HISTORIC PRESERVATION COMMISSION AGENDA ITEM EXECUTIVE SUMMARY			
		Agenda Item Title/Address:		COA: 318 S. 5 th St. (addition)	
		Proposal:		Addition to building	
		Petitioner:		Greg Richard, Batir Architecture	
Please check appropriate box (x)					
		PUBLIC HEARING			
		MEETING 10/7/15		X	
AGENDA ITEM CATEGORY:					
X	Certificate of Appropriateness (COA)			Façade Improvement Plan	
	Preliminary Review			Landmark/District Designation	
	Discussion Item			Commission Business	
ATTACHMENTS:					
Plan documents					
Architectural Survey page					
Minutes from 2009 review					
Photos of building					
EXECUTIVE SUMMARY:					
<p>Proposed is a building addition on the north side of the house located at 318 S. 5th St.</p> <p>In 2009, the Commission reviewed plans for the addition. The Commission supported the design but had requested additional information on the proposed window and siding replacement. The addition was not constructed at that time.</p> <p>In 2012, the Commission approved replacement of the existing windows with wood aluminum clad windows and replacement of the siding with Hardie cement fiberboard with Miratec trim and corners.</p> <p>In 2012, the Commission also approved ren

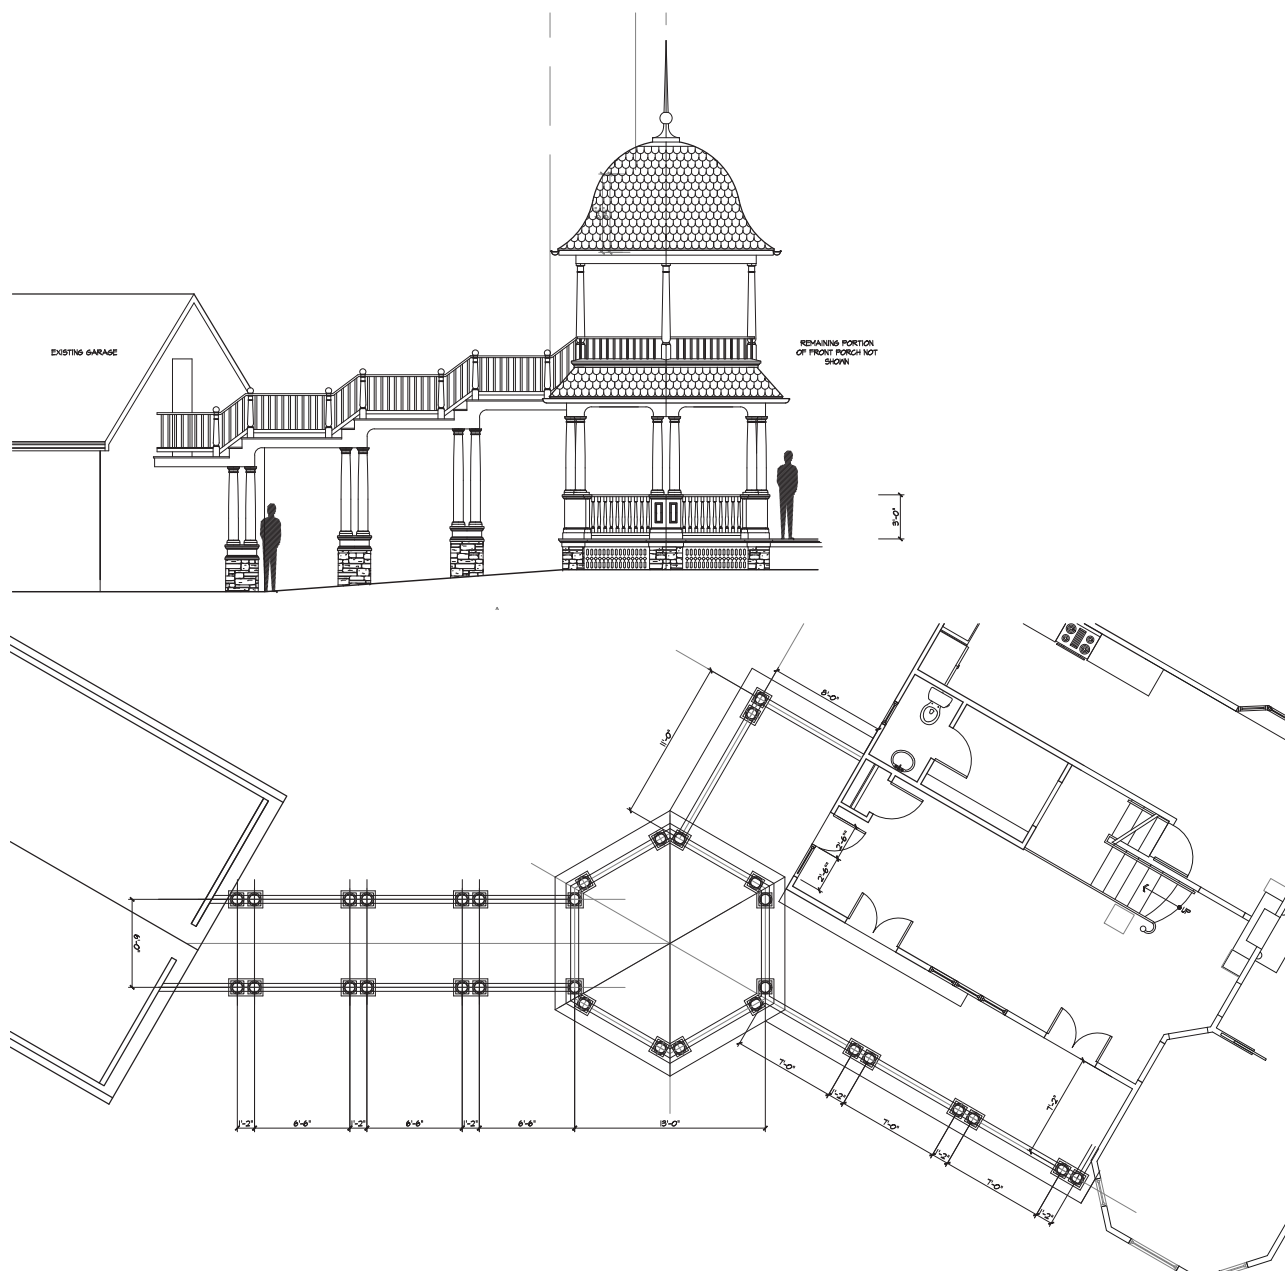
Mr. Norris confirmed with Ms. Price that the roof material on the octagon would be an asphalt shingle to match the roof. Brief discussion took place regarding the guardrail and options if code required the guardrail height to be 42-inches. Mr. Norris clarified that if hardy board material is not used for the siding, cedar siding will be used. Mr. Norris stated he approved of the plans and complimented the design.

Chairman Smunt commented that the building is unique and had all the original materials until recently. The proposed plan will bring a more appropriate siding material, suitable wood or substitute wood material back to the house. Chairman Smunt identified a window on the addition by the roofline that should match the existing. Ms. Price responded that it was an error on the drawings and she will address that so the window will match the existing. Chairman Smunt commented that the original porch had already been removed, so it is not an issue to rebuild the existing porch. Discussion took place regarding replacement windows. Chairman Smunt stated that wood replacement windows would be appropriate and questioned why only some would be wood and others would be aluminum clad. Ms. Price responded that cost is a factor, but again the intent is to keep the original look.

Chairman Smunt stated that the Commission should know specifically what materials would be used for the siding and windows, as well as which windows would be replaced with wood windows and which would be aluminum clad. All Commission members agreed. Discussion took place regarding which elevations would have wood replacement windows and which would have aluminum clad.

It was agreed that the Commission would table this item until the next meeting until all the specifics are decided.
